Access Compliance Report

Public Rights-of-Way

Intersection ID: 16836	Main Street: MCALWAY_RD	Cross Street: RIDGECREST_AV	Location: NW
ADA ID: EEDBFFCBE829	Ramp Type: PerpDiag	Initial Pass/Fail: Fail	Overall Compliance: No
			Severity Score: 33.75

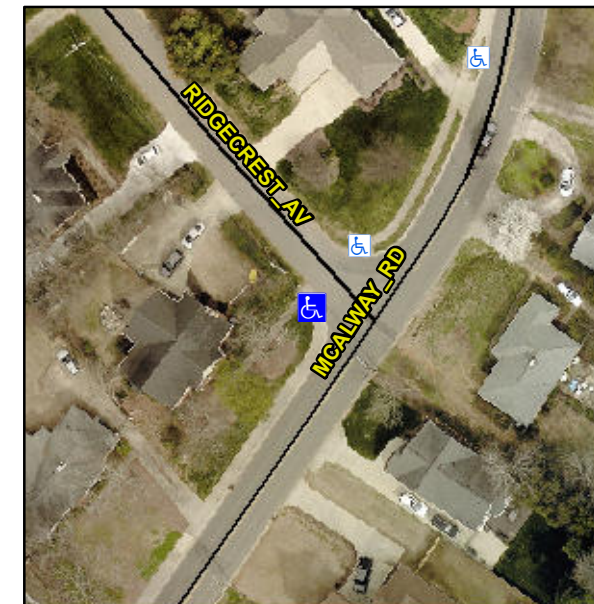
R304.5.1, R304.2.2, R304.5.3

Compliance	Description	Data	Compliance	Description	Data
N/A	Ramp Length (in)	72.0	No	Ramp Slope (%)	9.2
No	Ramp Width (in)	43.0	No	Ramp XSlope (%)	5.8
N/A	Flare Type LT	N/A	N/A	Flare Type RT	N/A
N/A	Flare Slope LT (%)	N/A	N/A	Flare Slope RT (%)	N/A
N/A	Flare Traversable LT?	N/A	N/A	Flare Traversable RT?	N/A
N/A	Landing Length (in)	N/A	N/A	DWS Provided?	N/A
N/A	Landing Width (in)	N/A	N/A	DWS Contrast?	N/A
N/A	Landing Slope (%)	N/A	N/A	DWS Length (in)	N/A
N/A	Landing X Slope (%)	N/A	N/A	DWS Full Width?	N/A
N/A	Landing Curb? (Y/N)	N/A	N/A	DWS Offset (in)	N/A
N/A	Shared Landing?	N/A			
N/A	Gutter Ponding?	N/A	N/A	Gutter Slope (%)	N/A
N/A	Gutter Lip Ht (in)	N/A	N/A	Gutter X Slope (%)	N/A
N/A	Painted X Walk1?	No	N/A	Painted X Walk2?	No
	X Walk 1 Direction	To SE		X Walk 2 Direction	To NE
N/A	X Walk 1 Width (in)	N/A	N/A	X Walk 2 Width (in)	N/A
	X Walk 1 Slope (%)	0.7		X Walk 2 Slope (%)	4.4
	X Walk 1 X Slope (%)	6.0		X Walk 2 X Slope (%)	0.9

Remove & Replace Curb Ramp With Two New Directional Ramps or Equivalent.
